NORTHEASTERN CONNECTICUT COUNCIL OF GOVERNMENTS

VERSION 3 ENGINEERING PLAN REVIEW

5-LOT SUBDIVISION

BEECHER ROAD

LOT DEVELOPMENT PLAN
SUBDIVISION OF LAND

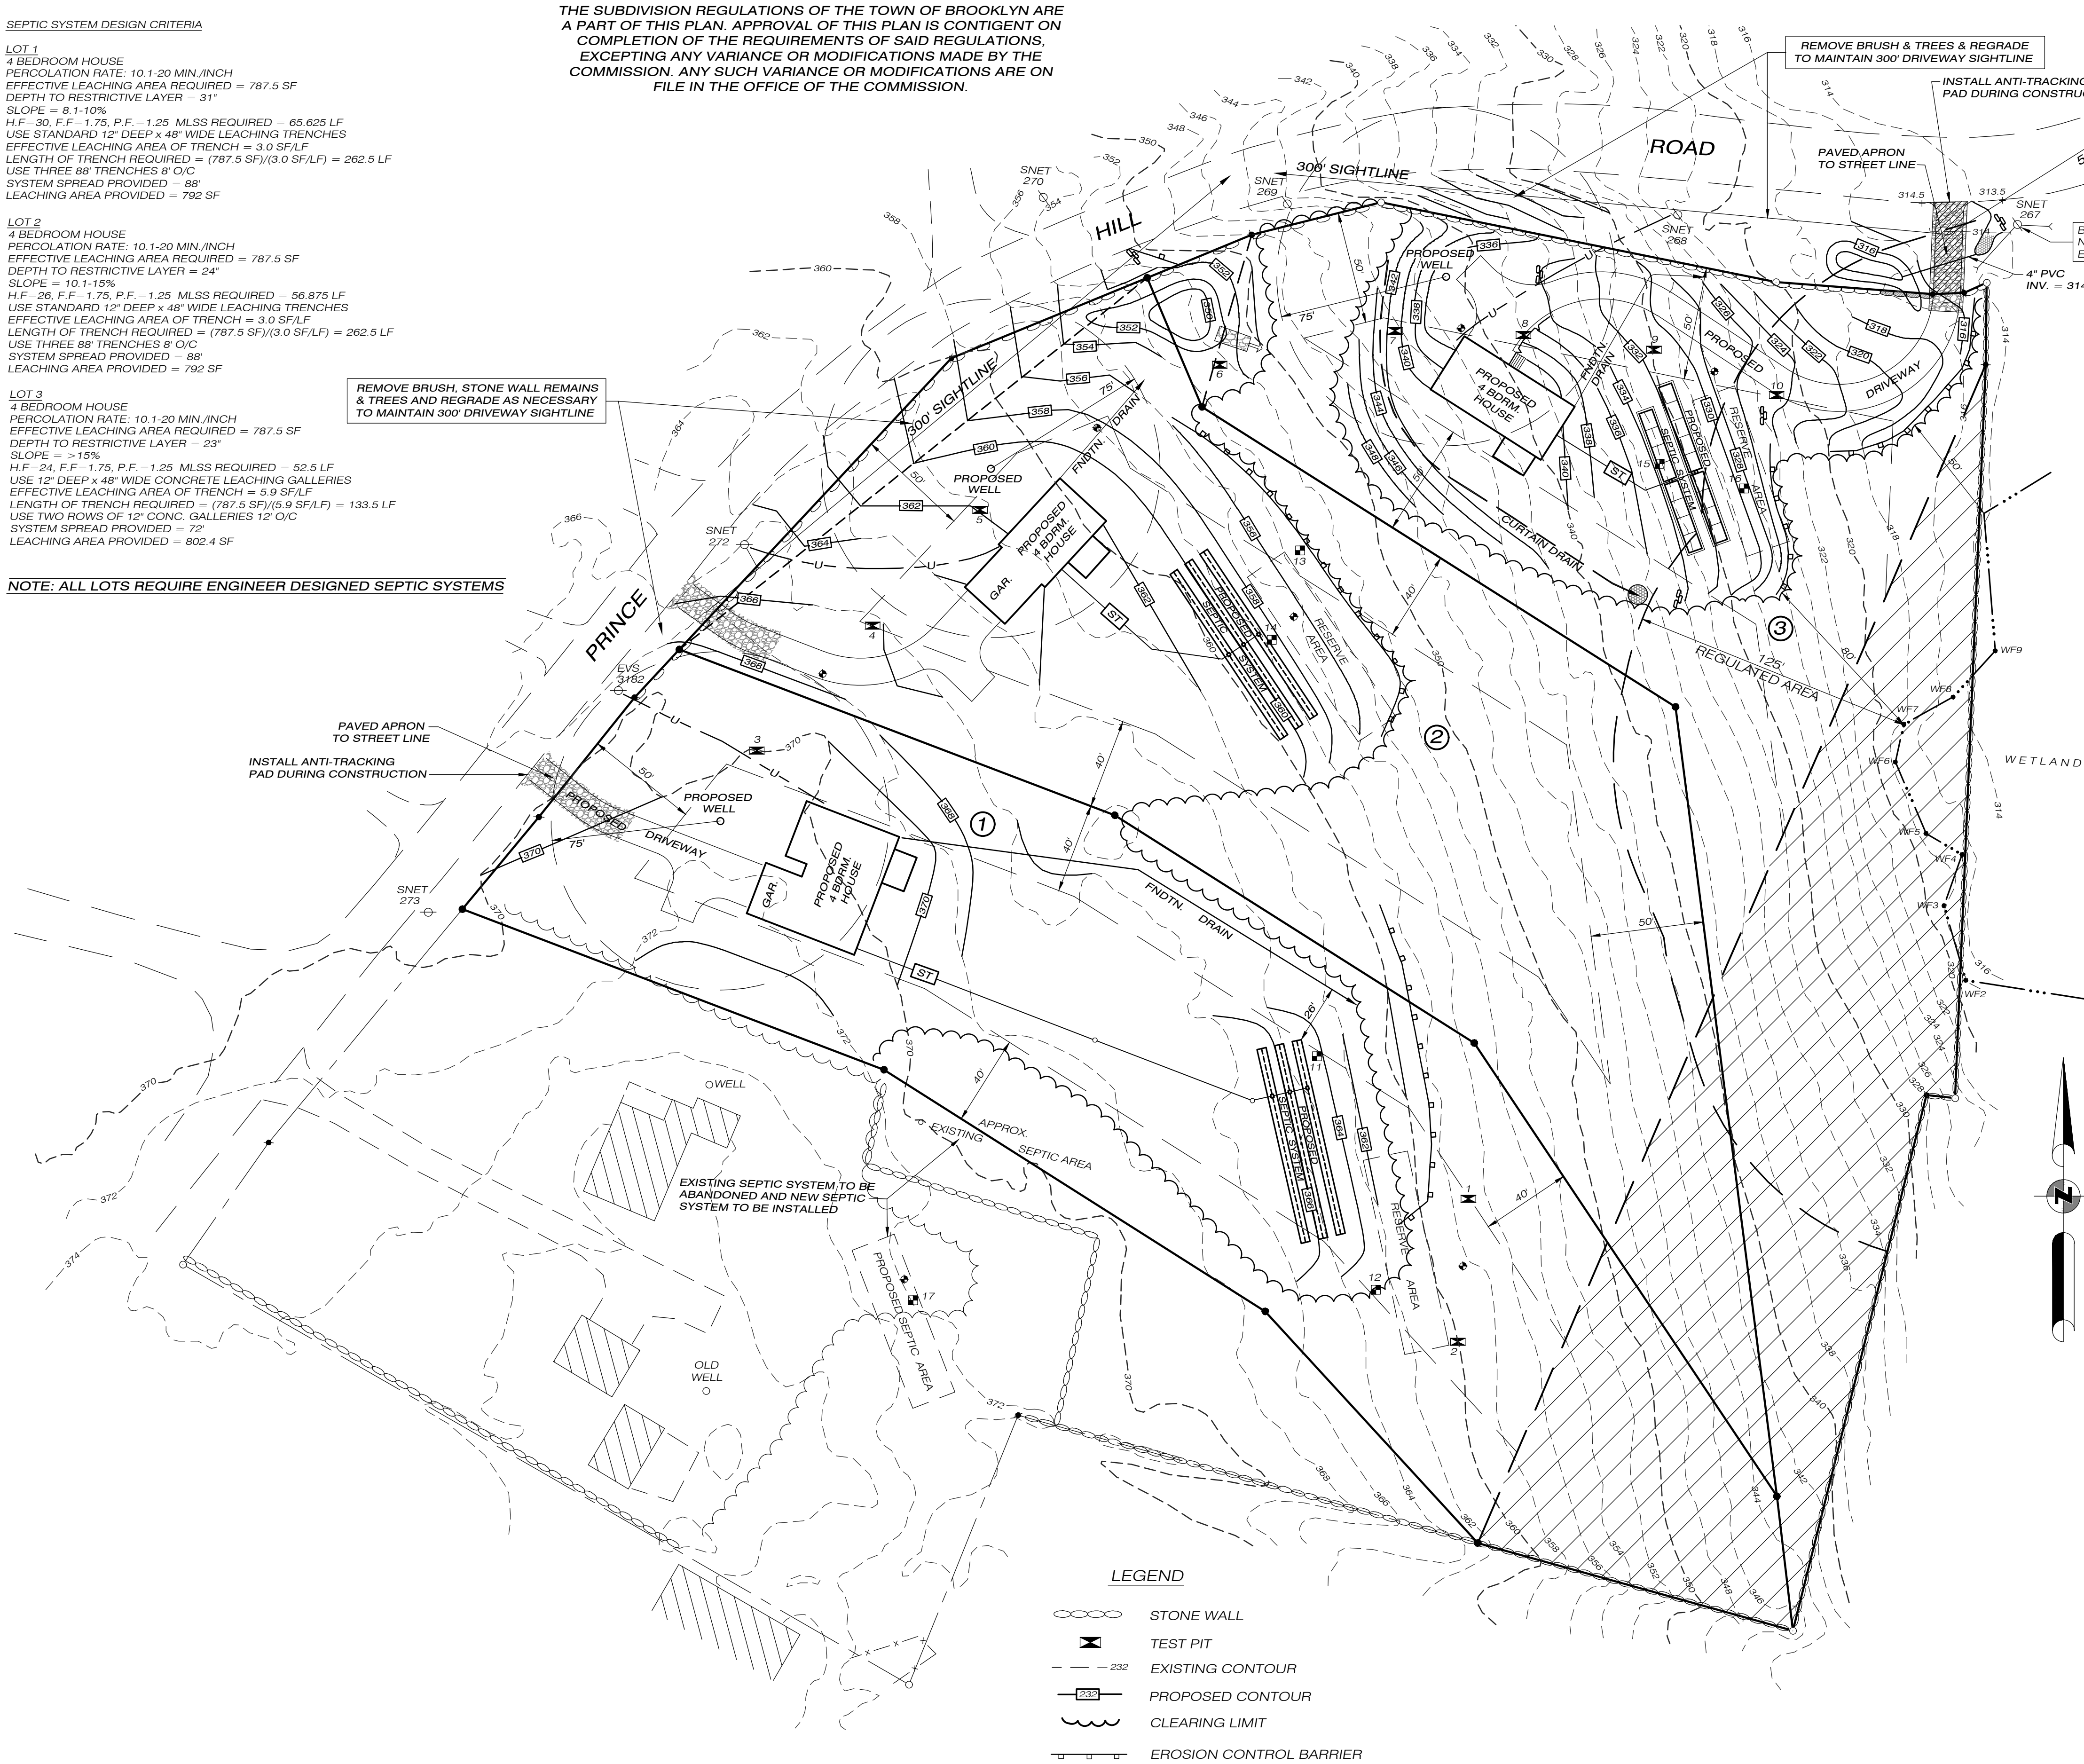
Even though a letter from NDDH to the Bells was submitted to you, PC Survey did not provide their explanation as requested. I believe it is important to know why this note was placed on the plan.

Even though a letter from NDDH to the Bells was submitted to you, PC Survey did not provide their explanation as requested. I believe it is important to know why this note was placed on the plan.
